Access Compliance Report

Public Rights-of-Way

(Curb Ramps)

Intersection ID: 17241	Main Street: S_CANTERBURY_RD	Cross Street: S_WENDOVER_RD	Location: SW
ADA ID: 4BC79593D672	Ramp Type: Directional1	Initial Pass/Fail: Fail	Overall Compliance: No
Severity Score: 12.5			
Codes/Mitigation Info/Possible Solution		Field Measurements/Component Compliance

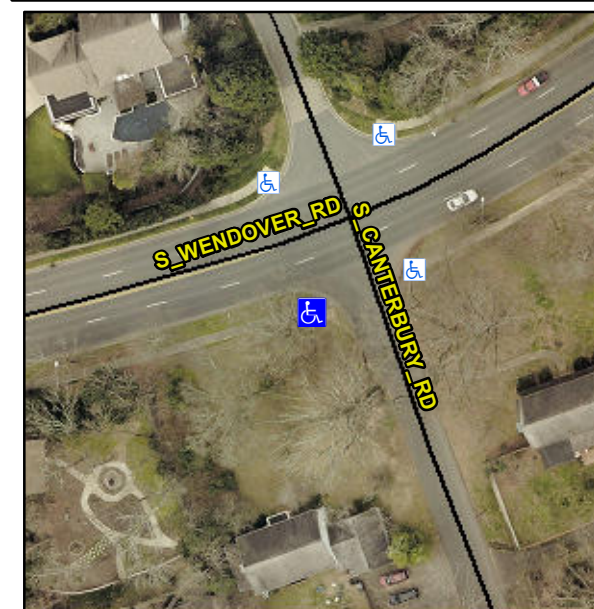
R304.5.3

Compliance	Description	Data	Compliance	Description	Data
N/A	Ramp Length (in)	67.0	N/A	Grade Break?	N/A
Yes	Ramp Width (in)	59.0	N/A	Grade Break Slope (%)	0.0
Yes	Ramp Slope (%)	0.1	N/A	Grade Break XSlope (%)	0.0
No	Ramp XSlope (%)	5.1			
N/A	Flare Type LT	N/A	N/A	Flare Type RT	N/A
N/A	Flare Slope LT (%)	N/A	N/A	Flare Slope RT (%)	0.0
N/A	Flare Traversable LT?	N/A	N/A	Flare Traversable RT?	N/A
N/A	Landing Length (in)	0.0	N/A	DWS Provided?	N/A
N/A	Landing Width (in)	0.0	N/A	DWS Contrast?	N/A
N/A	Landing Slope (%)	0.0	N/A	DWS Length (in)	N/A
N/A	Landing X Slope (%)	0.0	N/A	DWS Full Width?	N/A
N/A	Landing Curb? (Y/N)	N/A	N/A	DWS Offset LT (in)	N/A
N/A	Shared Landing?	N/A	N/A	DWS Offset RT (in)	N/A
N/A	Gutter Ponding?	0.0	N/A	Gutter Slope (%)	N/A
N/A	Gutter Lip Ht (in)	0.0	N/A	Gutter X Slope (%)	N/A
N/A	Painted X Walk1?	No		Road Slope (%)	5.8
	X Walk 1 Direction	To NE		Road X Slope (%)	1.7
	X Walk 1 Width (in)	N/A		Clear Space?	N/A

Remove & Replace Entire Ramp.
